WILPINJONG COAL PTY LTD

24 May 2019

**RE: Submission – Wollar Solar Farm Environmental Impact Statement
[SSD-9254]**

Figure 1-2 Lot and DPs of the proposal site.

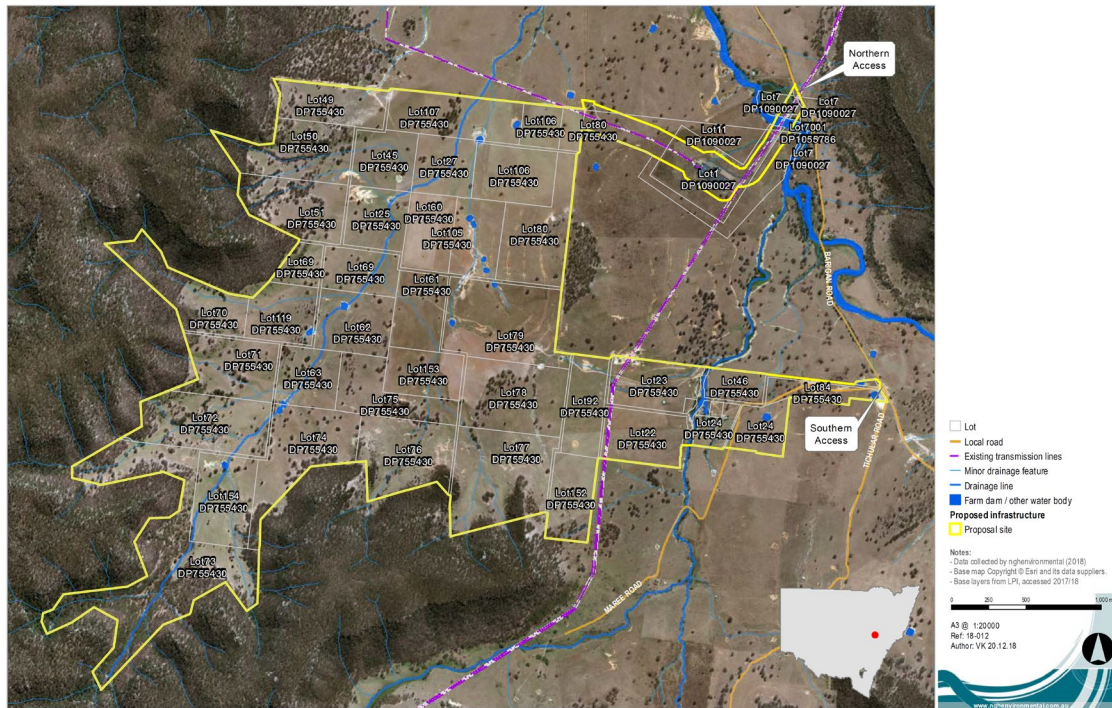
Based on the description in the EIS, it appears that WSD proposes to develop new passing facilities on Barrigan Road, which may involve land disturbance and potentially the clearing of remnant native vegetation within the road reserve.

WSD may not be the proponent for the road upgrades because there is an agreement between the Mid-Western Regional Council and WSD for Council to be the proponent for these works. However, if WSD is to be the proponent for the works, it is not clear that the works are included in the EIS specialist assessments, as the proposal area provided on Figure 1-2 of the EIS does not include them (reproduced below).

WCPL therefore suggests that the Department seeks confirmation from Mid-Western Regional Council as to the proponent of the proposed Wollar Solar Farm local road upgrades.
